Delegated Report (Refusal)		Analysis sheet		Expiry Date:		18/03/2025	
		N/A / attached		Consultation Expiry Date:		23/02/2025	
Officer					Application Number(s)		
Sam FitzPatrick					2024/5731/P		
Application Address					Drawing Numbers		
34a Netherhall Gardens London NW3 5TP					Please refer to decision notice.		
PO 3/4		Area Team Signature		C&UD		Authorised Officer Signature	
Proposal(s)							
Demolition of existing dwellinghouse and erection of three storey replacement house, including excavation of basement. Associated works including replacement of front boundary wall and erection of cycle and waste storage.							
Recommendation(s):		Refuse planning permission					
Application Type:		Full Planning Permission

1. Proposal

Figure 1: Block plan showing development site and surrounding properties.

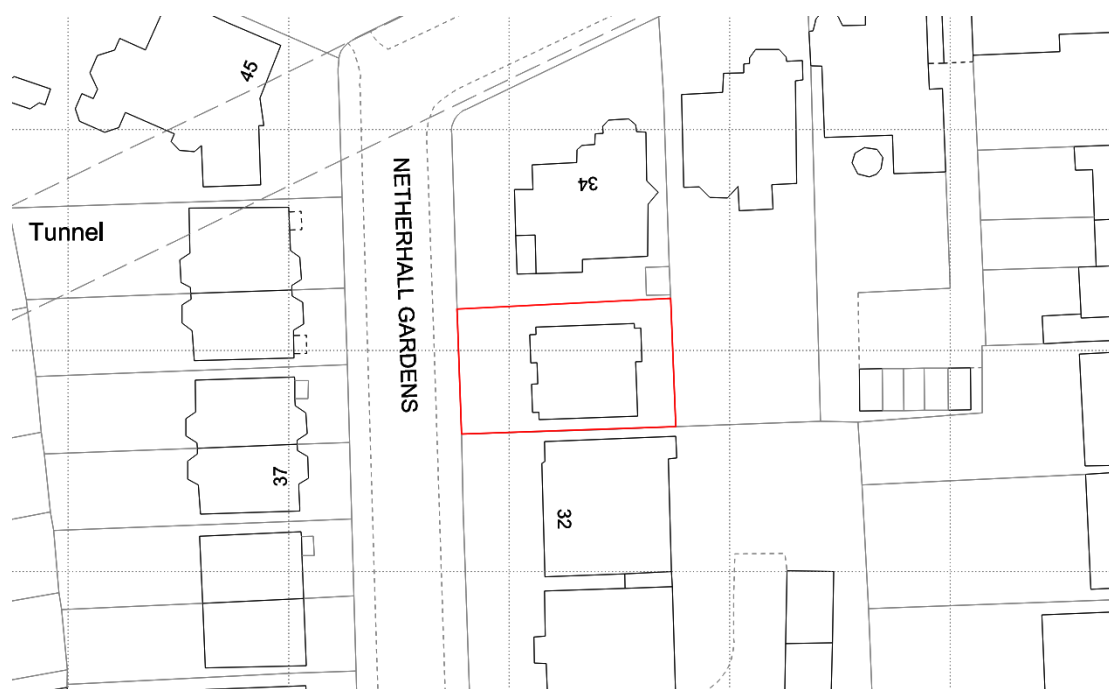
6.2. As previously noted, the fact that the proposed dwelling is located within the historic rear garden of 34 Netherhall Gardens means that the plot is quite constrained, and as a result any structure will be in close proximity to the neighbouring properties. Most notably,

the south elevation of the proposed structure is very close to the north elevation of 32 Netherhall Gardens, with a separation distance of approximately 2.3m. The following shows a block plan:
